AMENDMENT 2 AMENDEMENT 2

**Electromagnetic compatibility (EMC) –
Part 3-2: Limits – Limits for harmonic current emissions (equipment input
current ≤ 16 A per phase)**

This amendment has been prepared by subcommittee 77A: Low-frequency phenomena, of IEC technical committee 77: Electromagnetic compatibility.

Figure 2 – Illustration of the relative phase angle and current parameters described in 7.3 b)

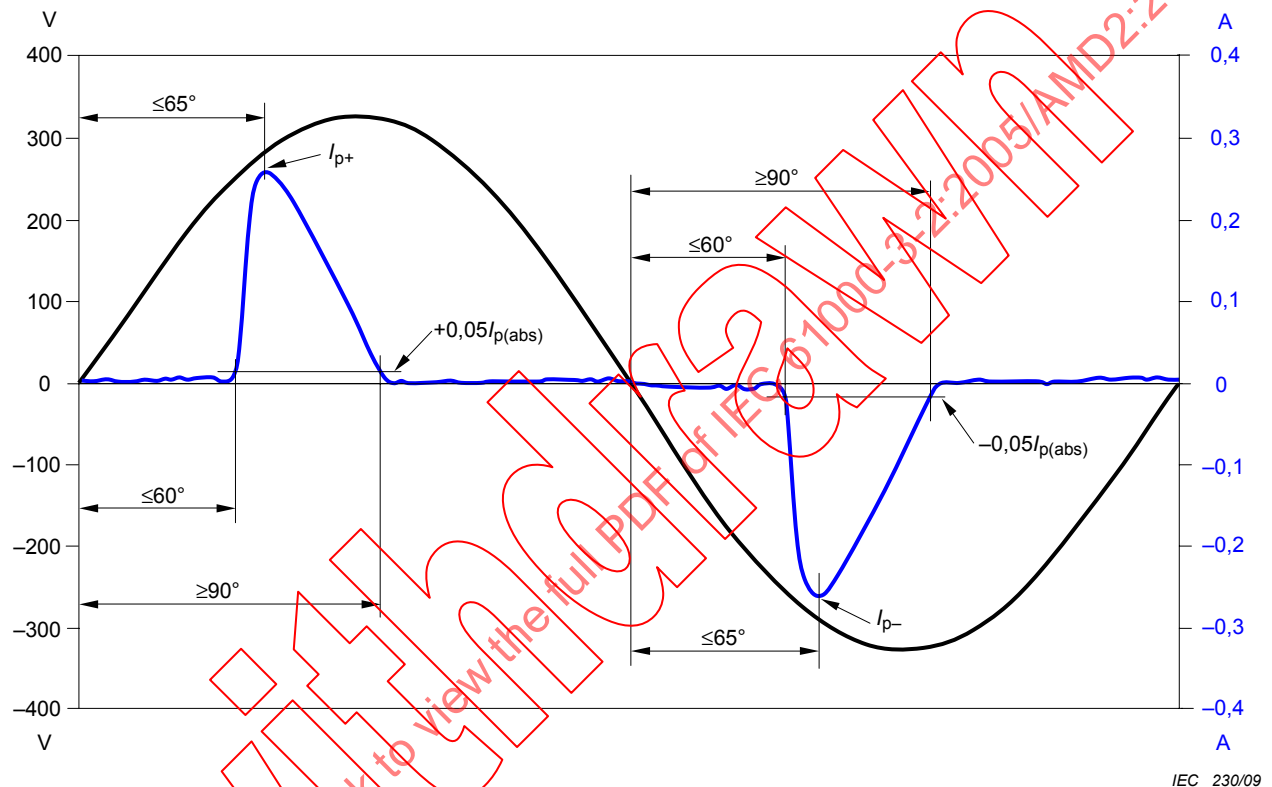
Replace the whole existing text of the second dashed item by the following new text:

- the third harmonic current, expressed as a percentage of the fundamental current, shall not exceed 86 % and the fifth harmonic current shall not exceed 61 %. Also, the waveform of the input current shall be such that it reaches the 5 % current threshold before or at 60° , has its peak value before or at 65° and does not fall below the 5 % current threshold before 90° , referenced to any zero crossing of the fundamental supply voltage. The current threshold is 5 % of the highest absolute peak value that occurs in the measurement window, and the phase angle measurements are made on the cycle that includes this absolute peak value. See Figure 2.

Add the following new Figure 2 after Figure 1:

NOTE $I_{p(abs)}$ is the higher absolute value of I_{p+} and I_{p-} .

Figure 2 – Illustration des caractéristiques en déphasage relatif et en courant décrites en 7.3 b)

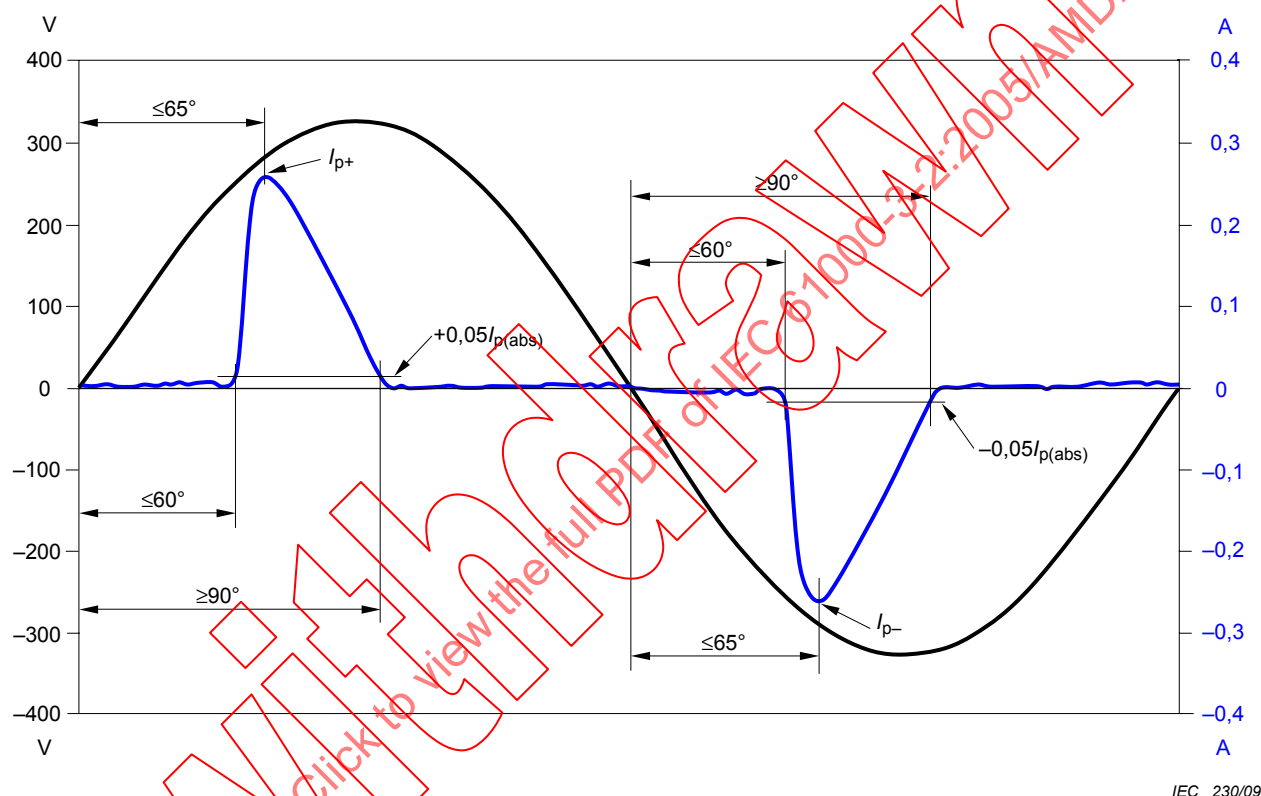
Remplacer l'intégralité du texte existant du second tiret par le nouveau texte suivant:

- l'amplitude du courant harmonique de rang 3, exprimée en pourcentage du courant fondamental, ne doit pas dépasser 86 % et l'amplitude du courant harmonique de rang 5 ne doit pas dépasser 61 %. De plus, la forme d'onde du courant d'entrée doit être telle qu'elle atteigne le seuil de 5 % en courant à 60° ou avant, qu'elle ait sa valeur de crête à 65° ou avant et qu'elle ne retombe pas en dessous du seuil de 5 % en courant avant 90°, par référence à n'importe quel passage par zéro du fondamental de la tension d'alimentation. Le seuil en courant correspond à 5 % de la valeur absolue la plus élevée de la valeur de crête qui se produit dans la fenêtre de mesure, et les mesures de déphasages sont faites sur la période qui inclut cette valeur absolue de la valeur de crête. Voir Figure 2.

Ajouter après la Figure 1 la nouvelle Figure 2 qui suit:

NOTE $I_{p(abs)}$ est la valeur absolue maximale de I_{p+} et I_{p-} .
